**GE Hitachi Nuclear Energy**

MFN 09-145

Subject: **Response to Portion of NRC Request for Additional Information Letter No. 263 Related to ESBWR Design Certification Application - RAI Number 7.7-11**

**RAI Number 7.7-11**

Figure 7.8-1. Simplified DPS Block Diagram

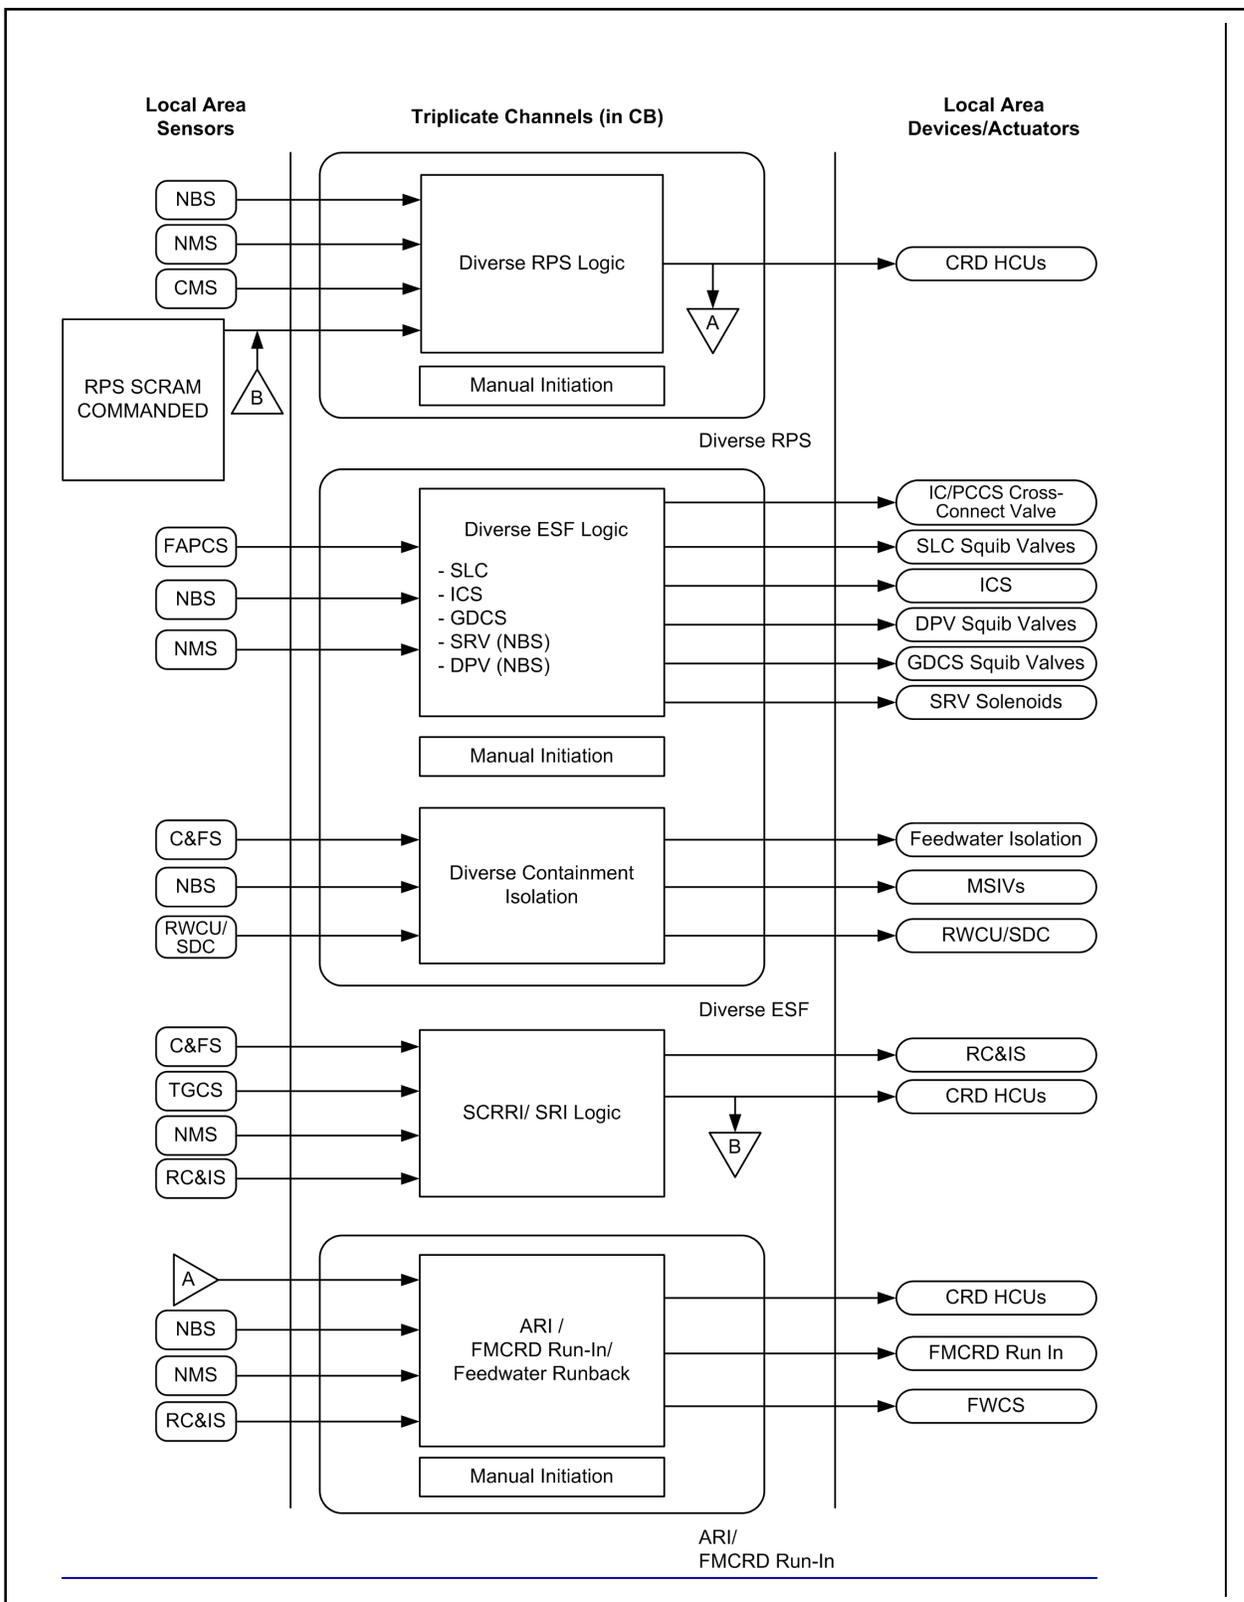
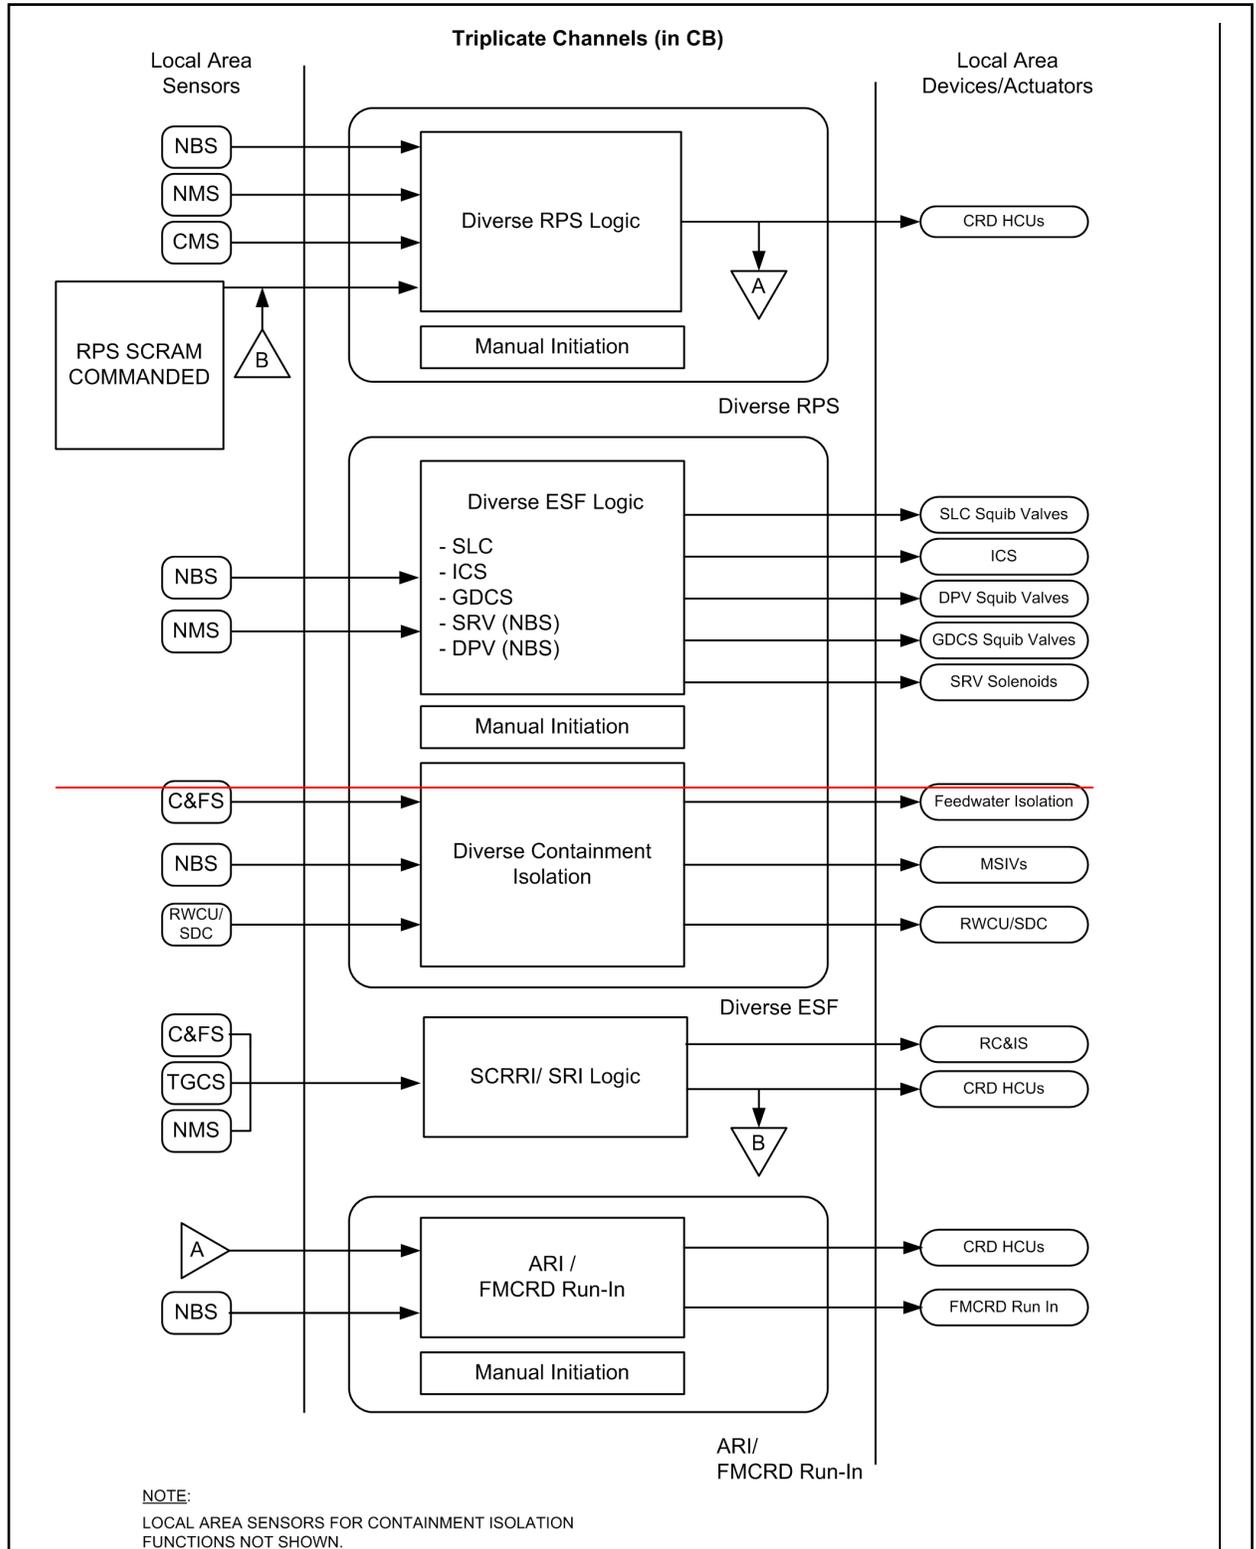
*DCD Tier 2 Figure 7.8-1, Simplified Diverse Protection System (DPS) Block Diagram, identifies several systems which, including the Nuclear Boiler System (non-safety-related portion), the Neutron Monitoring System, the Rod Control and Information System (RC&IS), the Feedwater Control System (FWCS), and the Reactor Water Cleanup/Shutdown Cooling System (RWCU/SDC), that provide diverse sense or actuation functions. However, neither DCD Tier 2 Table 7.1-1 nor the DCD Tier 2 Chapter 7 system discussions specify that the SRM on SECY 93-087 Item II.Q is applicable to these systems. In addition, while functions of the above systems are included in the applicant's D3 assessment (NEDO-33251); it is unclear which non-safety systems are specifically credited in the D3 assessment. Please clarify the following:*

- Clearly identify in NEDO-33251 and DCD Section 7.8 which non-safety-related are being specifically credited to perform diverse functions.*
- For those non-safety-systems specifically credited, clarify the applicability of SRM on SECY 93-087 Item II.Q and SRP BTP HICB-19 for these systems.*
- Clarify the applicability of Generic letter 85-06 to these systems, consistent with the staff discussion in RAI 7.8-8.*

a) DCD Tier 2 Figure 7.8-1, "Simplified DPS Block Diagram," shows the interfacing systems that contain components that are subject to the guidance contained in SRM on SECY 93-087 Item II.Q, SRP BTP HICB-19, and Generic Letter 85-06. These

Figure 7.8-1 also will be revised for completeness to depict the feedwater runback function described in Subsection 7.8.1.1.4 and shown in Figure 7.8-2, and the RC&IS input to the SCRRI/SRI logic as listed in Subsection 7.8.1.1.3. Figure 7.8-1 and Table 7.8-3 will be revised to depict the FAPCS sensor interface used to open the IC/PCCS expansion pool to equipment pool cross-connect valve described in Subsection 7.8.1.2.5.

DCD Tier 2, Figure 7.8-1, will be revised for Revision 6 for completeness to ensure that all DPS interfacing systems described in Section 7.8 are represented in Figure 7.8-1.

[The guidance contained in the SRM on SECY 93-087 Item II.Q, SRP BTP HICB-19, and Generic Letter 85-06 is applicable to the DPS and to all portions of the systems show in Figure 7.8-1 and identified in Table 3.2-1 that are required to perform sense and actuate functions in support of the diverse instrumentation and control functions described in this Section.](#)
